Appendix 3: Transportation Peer Review prepared by BBO

Memo

Job name Matamata Indoor Sports Stadium

Subject Matamata Piako District Council – Matamata Indoor Sport Stadium

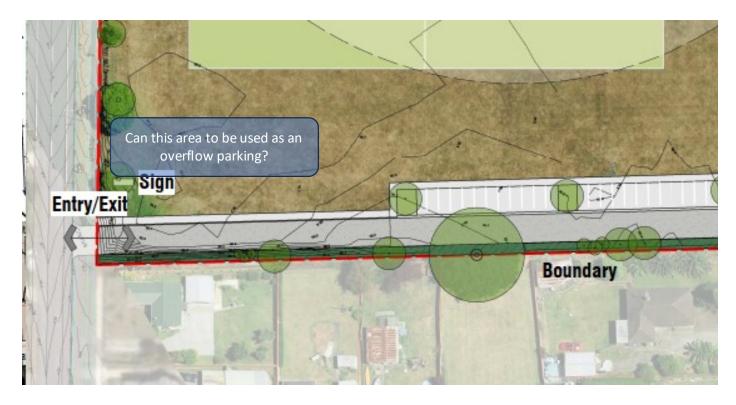
Is it possible to allow some space on-site for an overflow parking, as highlighted below?

Figure 1: Recorded Parking Occupancy

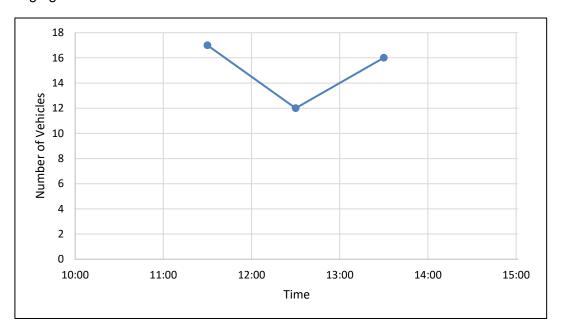
Council has requested commentary in relation to the average parking occupancy on Station Road, and in particular, the number of the available 126 spaces that will be available during large events.

Figure 1 shows a maximum parking occupancy of 17 vehicles at 11.30am, with all vehicles parked on Station Road. The majority were parked either at the eastern end near the neighbourhood shops, or at the western end immediately east of Smith Street. There were few vehicles parked adjacent to the site.

Figure 2: Potential Additional On-Site Parking

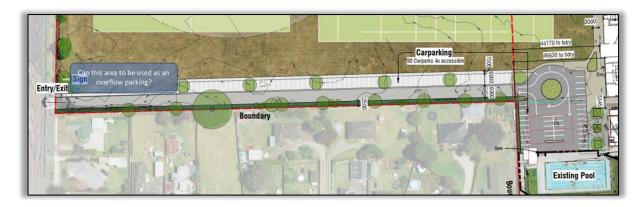
Council has suggested increasing the on-site parking to be provided, as shown of the figure below.

Section 1 of this report notes that, for indoor recreation buildings, the District Plan requires 93 on-site car parking spaces to be provided, while the expected peak parking demand was assessed at 80 spaces. A total of 94 on-site car parking spaces are proposed, which exceeds both the District Plan parking requirement and the expected typical peak parking demand. The transportation assessment report assessed that an appropriate level of parking is proposed to accommodate the expected typical day to day use of the stadium, without the need for overflow parking onto the adjacent roads. It is therefore assessed that any additional on-site parking provided within the area identified above will only be used for the larger events, of which, up to six are proposed each year.

It is expected that this area could provide up to approximately 20 spaces, which would reduce the expected overflow parking demand for the large events from 88 spaces to 68 spaces. It is therefore expected that there will still be overflow parking associated with these larger events and that a TPMP will still be required. Given that this area would be used up to six times per year, is insufficient to accommodate the full expected overflow parking demand, and that a travel management plan will still be required for the remaining overflow parking, it is assessed that there is little benefit in providing the additional parking. It is however noted that the TPMP may choose to use this area for additional parking if considered beneficial.
